Technical Service Bulletin

57J3 UPDATE

Door Seam Cavity Sealing – (NVLW)

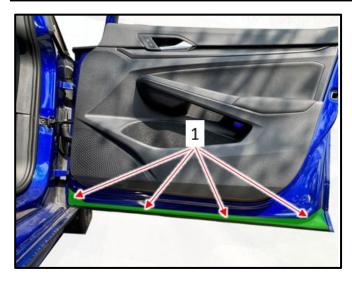
Apply cavity wax to the inside of all four doors at the lower seams in the area indicated <arrows>.

The cavity wax should be applied the length of the seams.

The area where cavity wax is to be applied **INSIDE** the door <1> is shown from the outside for clarity. **CAVITY WAX IS ONLY TO BE APPLIED INSIDE THE DOOR, NOT THE OUTSIDE!**
